Access Compliance Report Public Rights-of-Way (Curb Ramps)

Intersection ID: 31876	Main Street: ARABELLA_DR	Cross Street: WILLIAMS_GLENN_RD	Location: SW
ADA ID: D7D968330A07	Ramp Type: Perp	Initial Pass/Fail: Fail	Overall Compliance: No
		Severity Score: 12.5

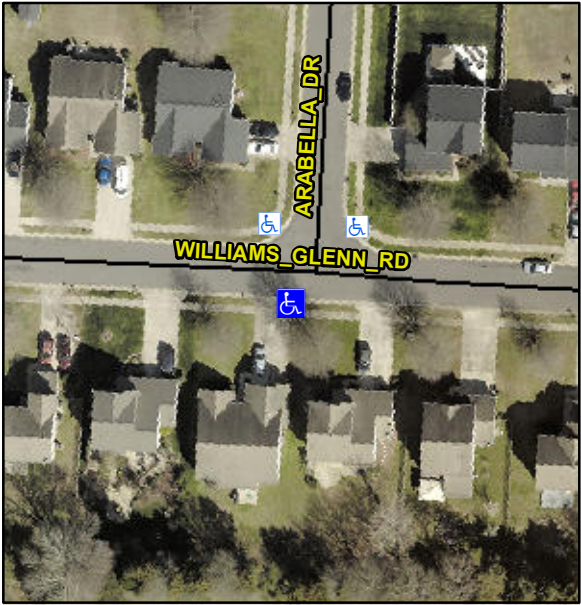
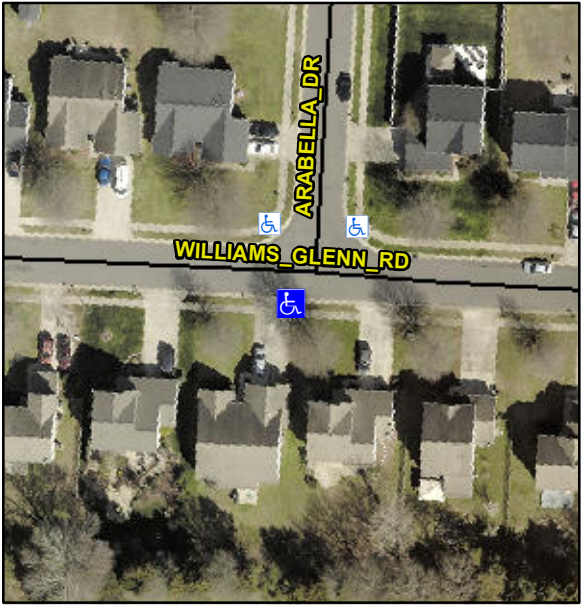
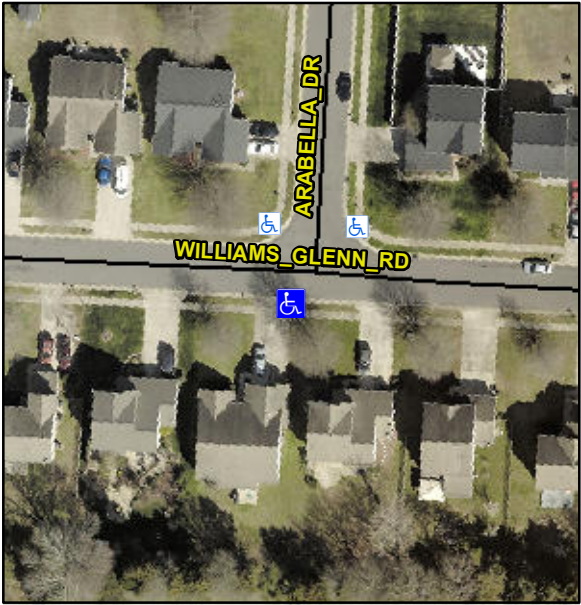
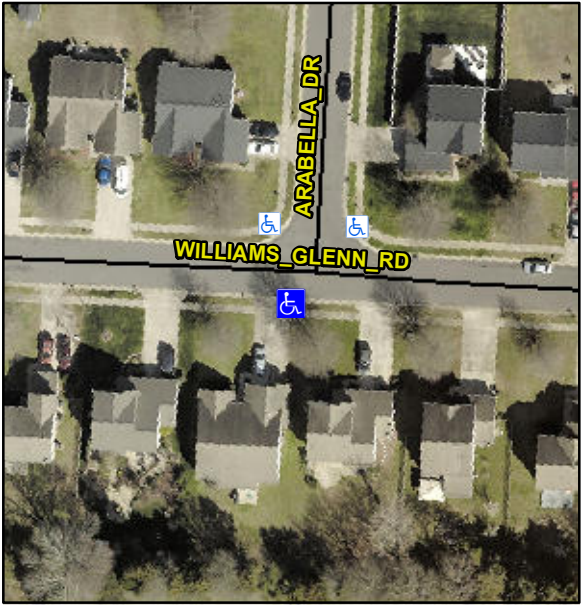
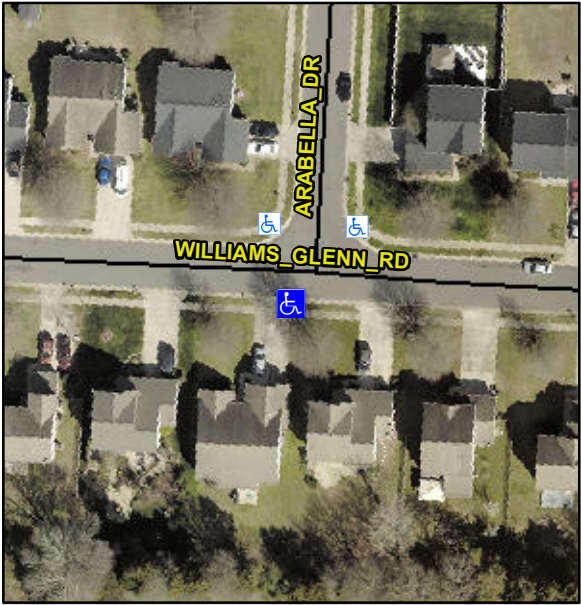
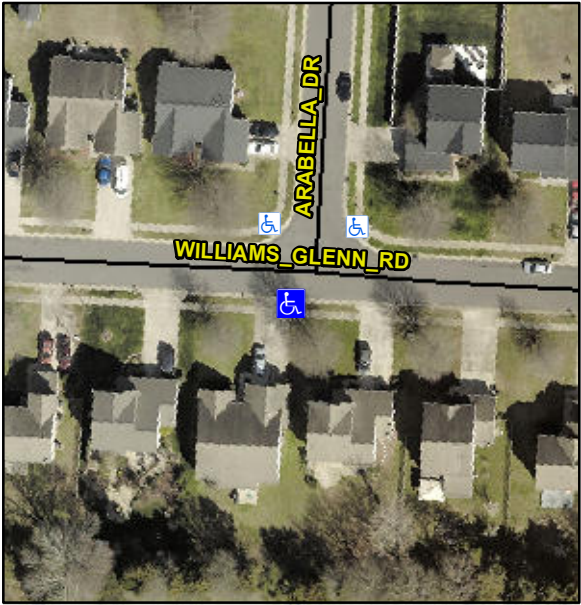
Codes/Mitigation Info/Possible Solution			Field Measurements/Component Compliance			
	Possible Solutions:		Compliance	Description	Data	
	Remove & Replace Entire Ramp.		Yes	Ramp Length (in)	47.0	Yes
	Surveyor Notes:		No	Ramp Width (in)	48.0	No
	N/A		N/A	Flare Type LT	N/A	N/A
	PROW/ADA:		N/A	Flare Slope LT (%)	N/A	N/A
	R304.5.3		N/A	Flare Traversable LT?	N/A	N/A
			N/A	Flare Slope RT (%)	N/A	N/A
			N/A	Flare Traversable RT?	N/A	N/A
			N/A	DWS Provided?	N/A	N/A
			N/A	DWS Contrast?	N/A	N/A
			N/A	DWS Length (in)	N/A	N/A
			N/A	DWS Full Width?	N/A	N/A
			N/A	DWS Offset (in)	N/A	N/A
			N/A	Gutter Ponding?	N/A	N/A
			N/A	Gutter Lip Ht (in)	N/A	N/A
			N/A	Painted X Walk1?	No	N/A
			N/A	X Walk 1 Direction	To NW	N/A
			N/A	X Walk 1 Width (in)	N/A	N/A
			N/A	X Walk 1 Slope (%)	3.5	N/A
			N/A	X Walk 1 X Slope (%)	0.9	N/A
			N/A	Ramp inside XWalk1?	N/A	N/A
			N/A	Road Slope (%)	N/A	N/A
			N/A	Road X Slope (%)	N/A	N/A
			N/A	Any Obstructions?	N/A	N/A
